# SITE PLAN & ARCHITECTURAL COMMISSION AGENDA MARCH 4, 2016

IN THE MATTER OF SITE PLAN AND ARCHITECTURAL COMMISSION )  
FILE AC-15-155 APPLICATION FOR PROJECT REVIEW SUBMITTED ) ORDER  
BY OREGON ARCHITECTURE, INC. )

AN ORDER granting approval of plans for the construction of a 4,100 square foot building encompassing a Five Guys Burgers restaurant and a single tenant space with drive through, located on the east side of Center Drive approximately 1,000 feet north of Garfield Street on a 0.40 acre site located within the C-R (Regional Commercial) zone district.

**SD1.0**  
SHEET

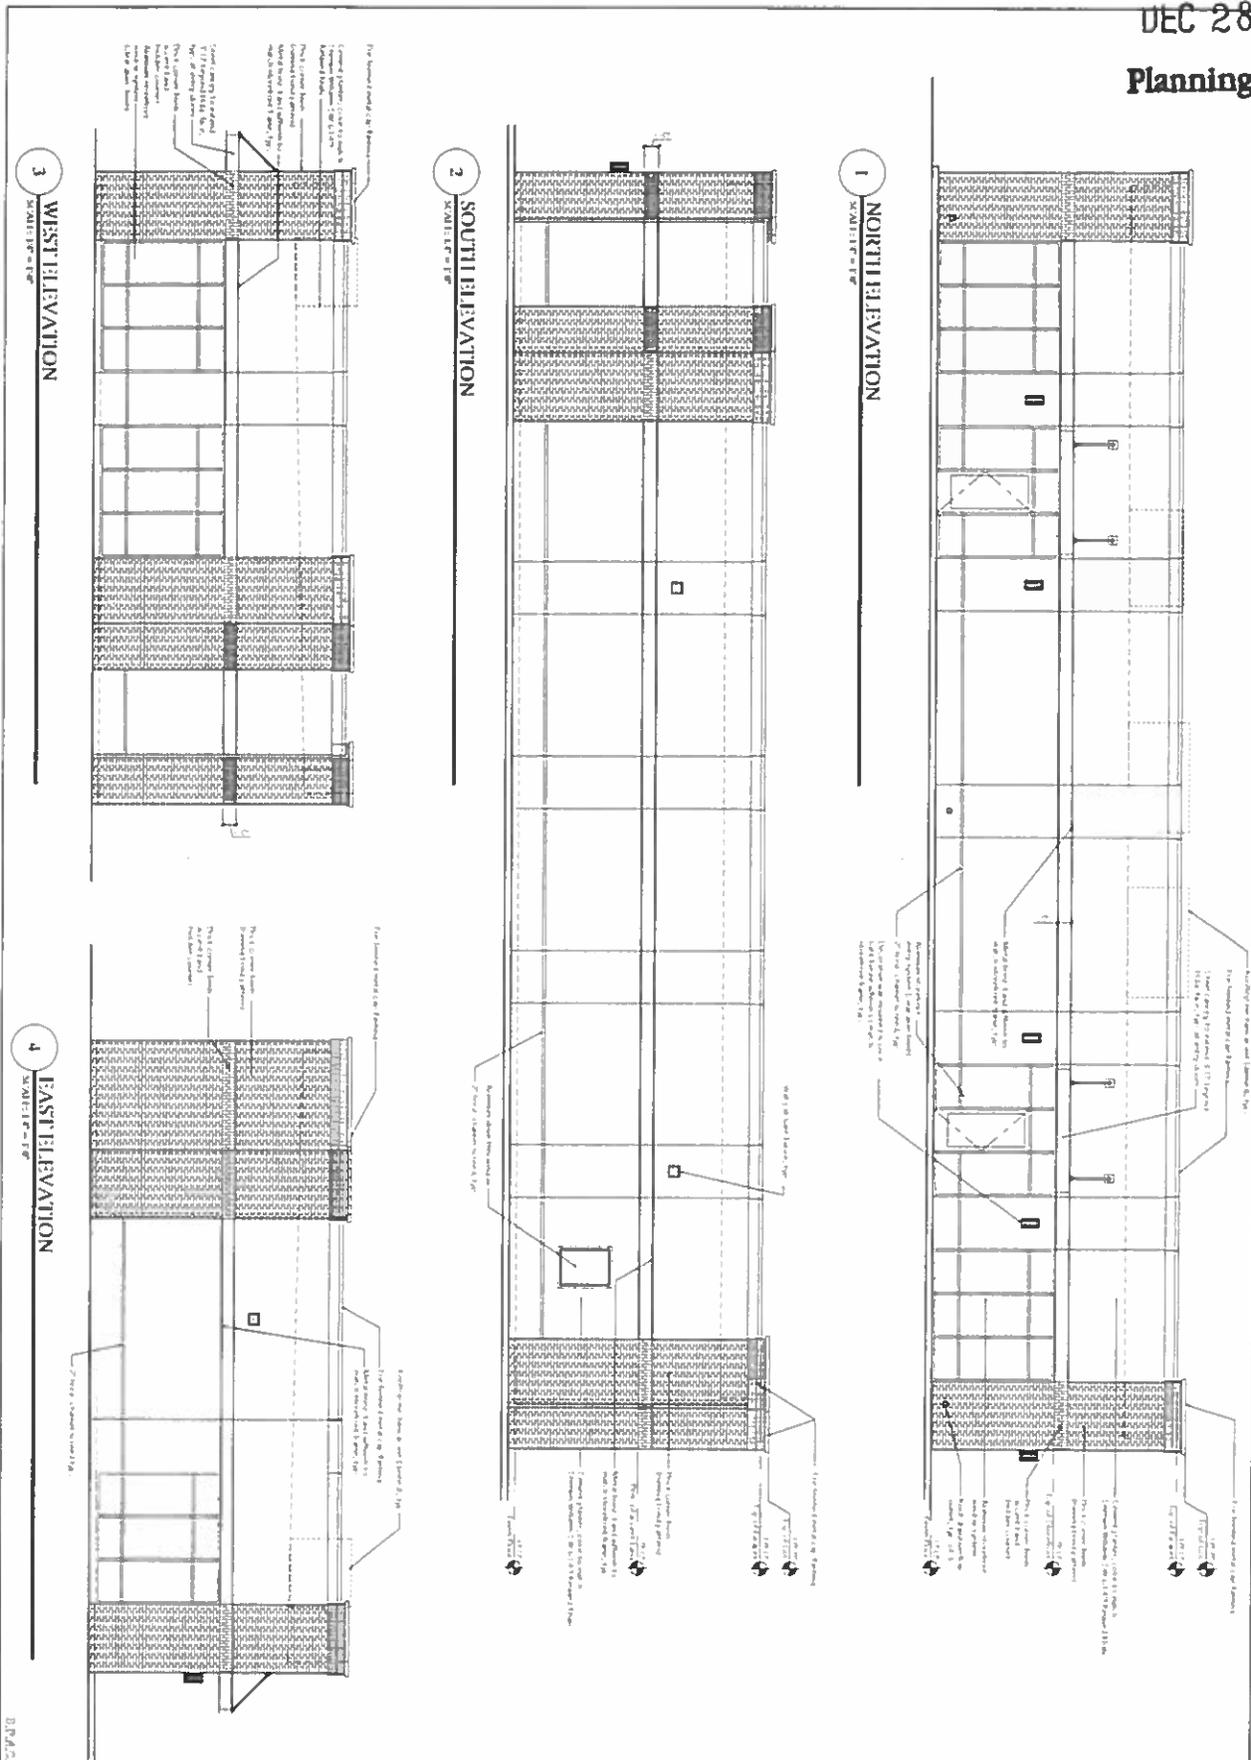
A bus stop pad will be constructed along Center Drive. It will be located immediately adjacent to the pedestrian pathway that will link business entrances to Center Drive. The site plan demonstrates the pedestrian route crossing over the drive through queuing lane and continuing east of the new building to the existing commercial building on the east. Staff is including a discretionary condition of approval (Exhibit A) that a more direct pedestrian crossing be provided over the drive aisle to the east by turning a portion of the proposed landscape planter into part of the pedestrian route similar to the concept provided in Exhibit R.

As noted above, the pedestrian route crosses two drive aisles. The appearance of the crossings represented on the site plan seems to suggest the crossings are demarcated with paint stripes. There is no note provided to the pavement material of the crossings. Section 10.775 of the MLDC Pedestrian Walkway Design Standards requires a pavement material that will clearly delineate the pedestrian pathway from the drive-through aisle and drive aisle on the east side of the building. A condition of approval (Exhibit A) has

The site plan indicates that there is a minimum of 64 parking spaces required for this development overall. The proposed site plan provides a total of 25 new parking spaces, providing a total number of 73 spaces for the overall development. The existing 9,257 square foot building requires 34 parking spaces, based on the current tenant mix, and would require 42 spaces if the entire building was completely occupied with commercial uses at parking ratio of 4.5 spaces per 1,000 square feet. The new building requires 30 spaces, based on the proposed uses. With the additional 10 parking spaces secured by agreement on the adjoining property, the development provides a total of 83 spaces, which is 19 more spaces than the minimum required. In the event that the tenant mix on the rear building changed to all retail/commercial use, the proposed development would still exceed the minimum requirement by 11 spaces.

- e. Comply with the Rogue Valley Sewer Services Report dated January 21, 2016 (Exhibit "O").
2. Prior to issuance of building permit, the applicant shall provide a site plan site plan reflecting pedestrian pathway compliance with Section 10.775 of the MLDC.

# Conceptual Pedestrian Crossing over East Drive Aisle

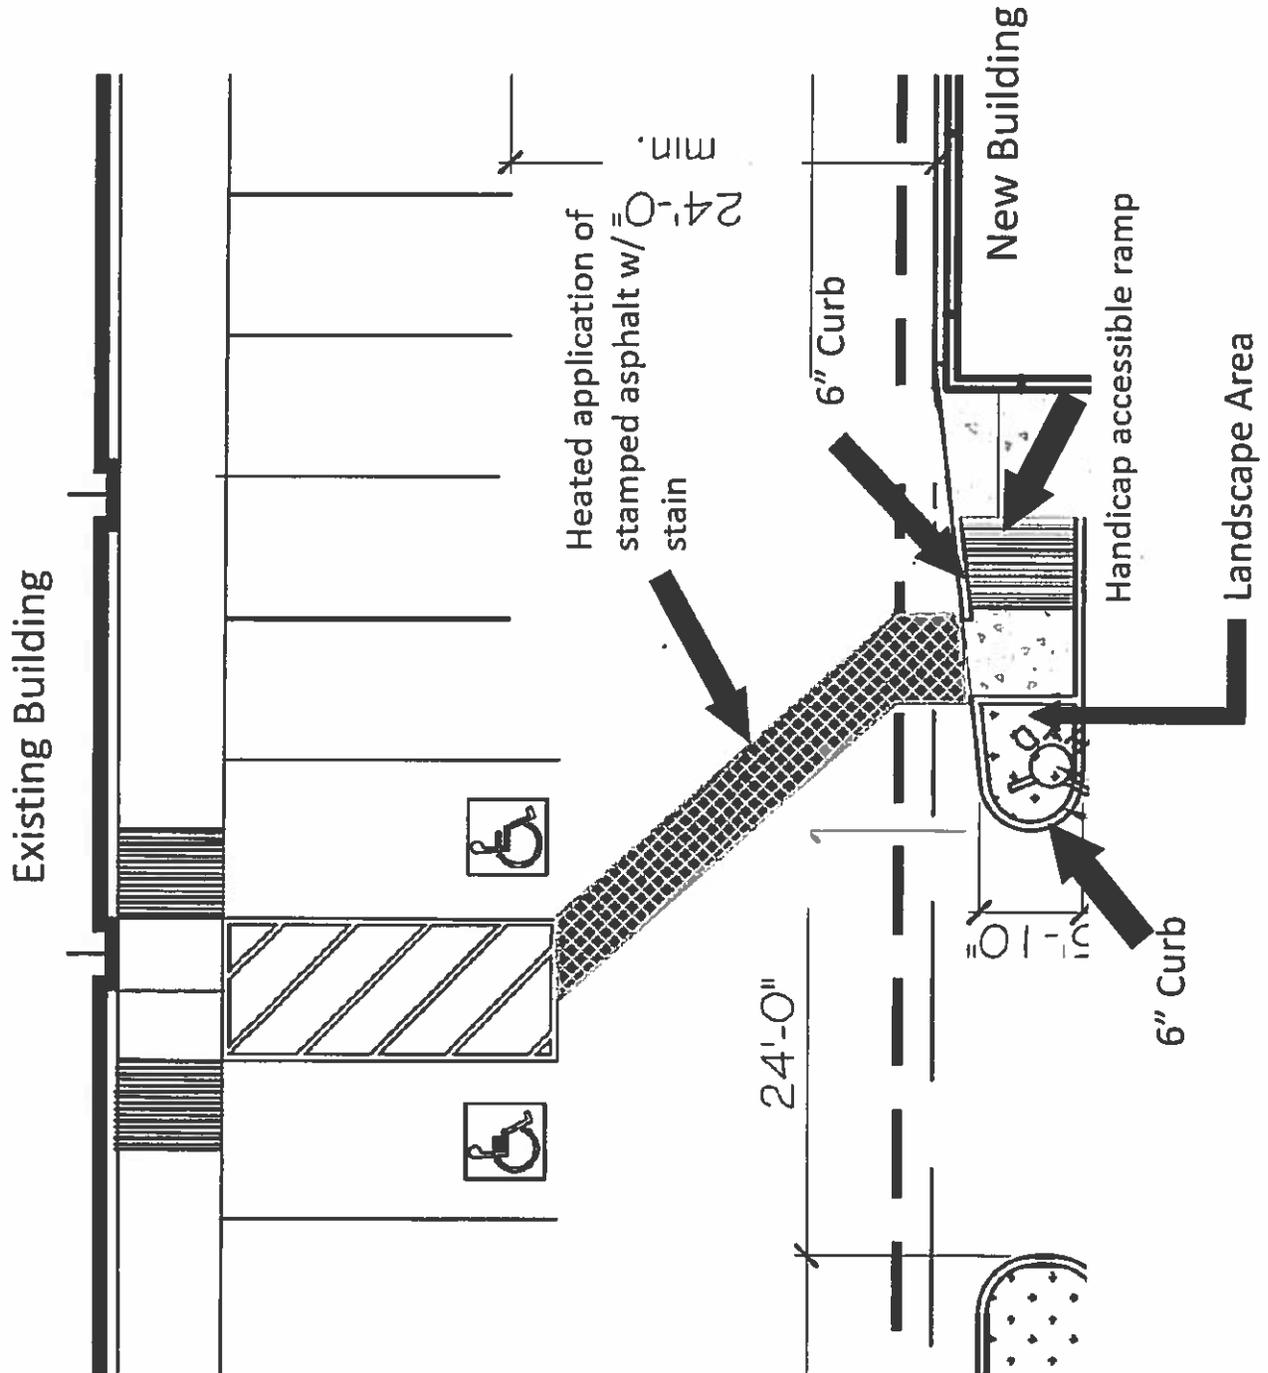
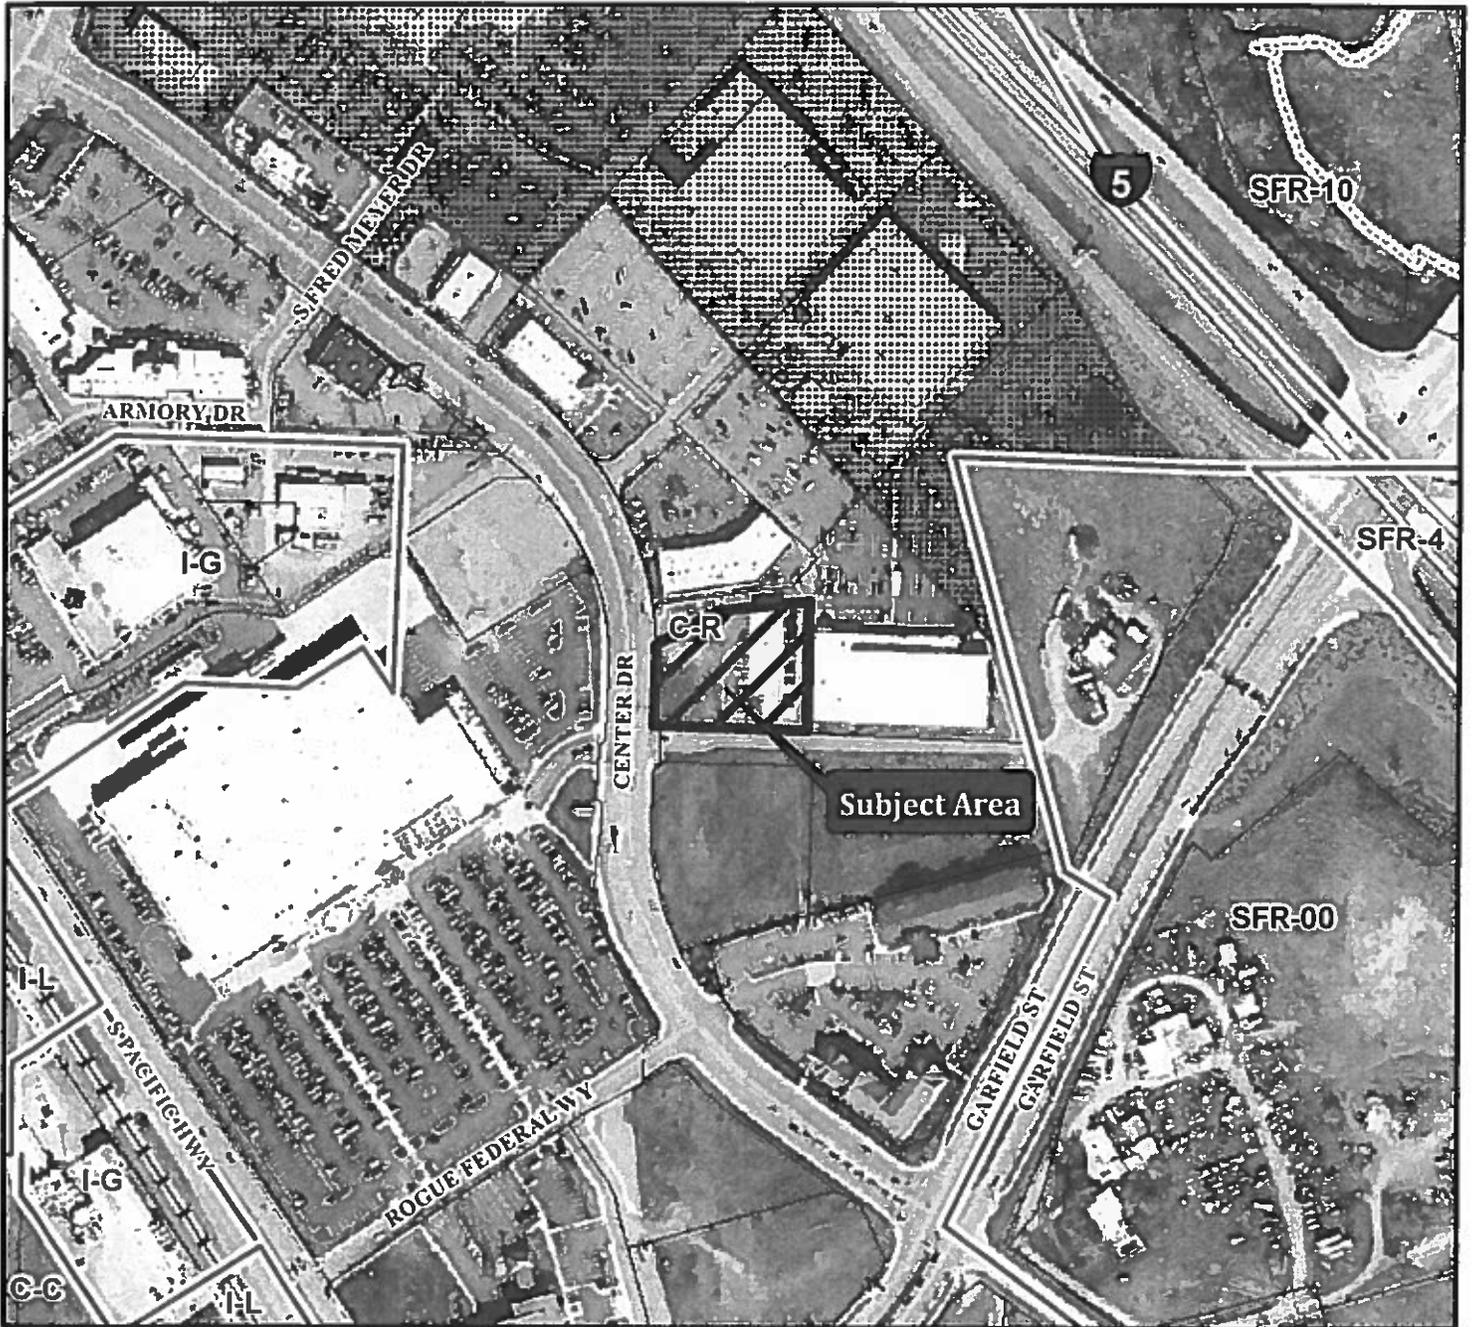
The provisions of Section 10.775 note that pedestrian walkways shall be separated from the parking area at crossings by a change in grade, application of different paving materials or with speed bumps. As the driveway to the east of the building already exists, staff would suggest a heat treated stamped and painted asphalt. As noted above, other alternatives such as speed bumps or a raised asphalt table, with paint striped delineation could also suffice for meeting the requirement.

5. The applicant shall construct a 8-foot deep by 18-foot long concrete pad for the future development of a bus shelter by RVTD and grant an 8-foot deep by 23-foot long easement to RVTD as to accommodate the future RVTD construction of a concrete pad and cart corral.
6. Prior to issuance of building permit, the applicant shall provide a revised site plan reflecting a more direct crossing of the east driveway as illustrated in Exhibit "R".
